DISPUTES REVIEW BOARD RECOMMENDATION

Ref: SR-597 (Dale Mabry) From W. of Fletcher Ave. to Carrollwood Springs Blvd.. Contract No: T7258, Financial Project No: 426161-1-52-01. Disputes Review Board hearing regarding the quantity of structural treated timber quantity.

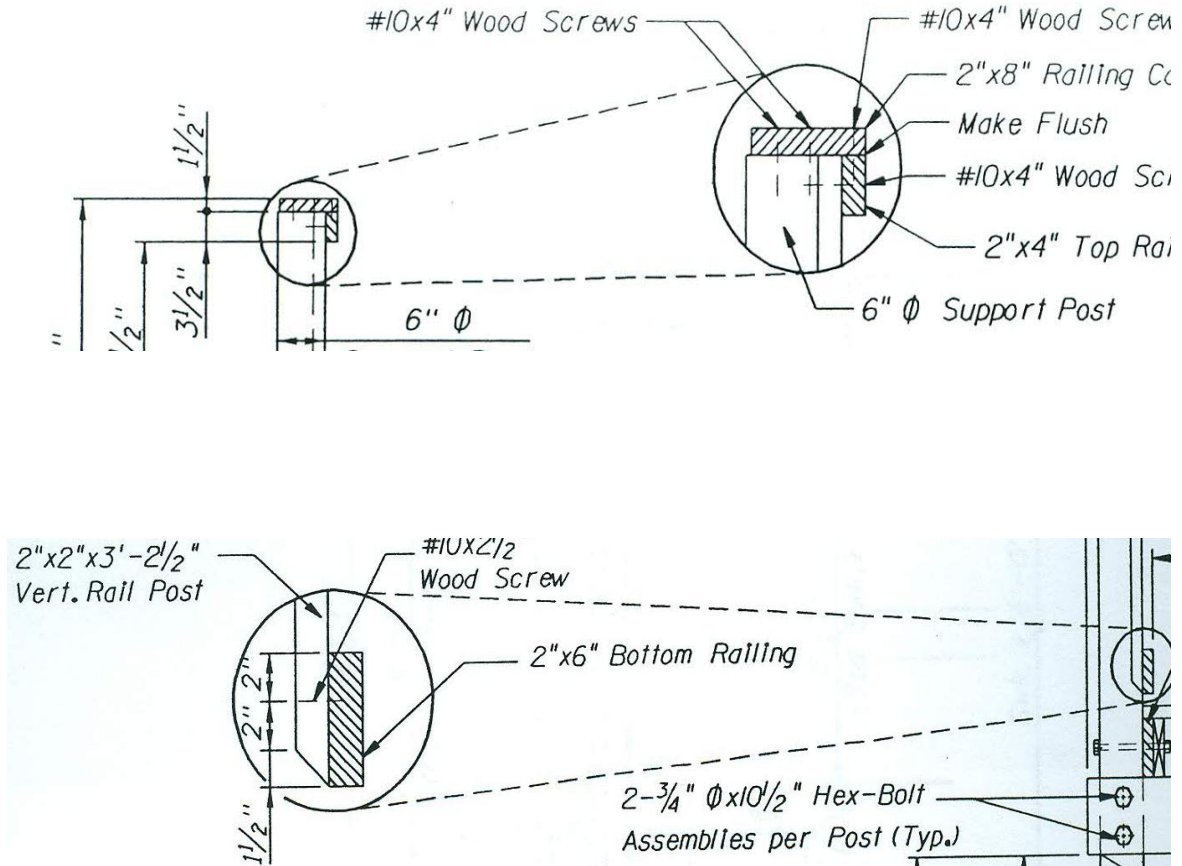
4. The Standard Specification 470-14 Method of Measurement states part that; *The quantity to be paid for will be the plan quantity, in feet board measure, of such timber actually incorporated in and forming a part of the completed structure. While the method of calculation will be; ...calculating the quantity of timber, the width and thickness will be taken as the **actual** (emphasis added) sizes shown in the plans or ordered by the Engineer.* The following drawings from page 134 of the plan sheets show the measurements of the timbers to be actual, not nominal.

As can be seen from, the drawings the 2"x6" Bottom Railing is shown to be actually 5 1/2" wide. The 2"x8" railing called for in the top picture is shown to be actually 1 1/2" thick. The specification states that the actual sizes of the timbers used will be the quantity calculated for pay.

Based on the contract documents the Board finds that there is no entitlement to the Contractor for additional compensation for the treated timber quantities.
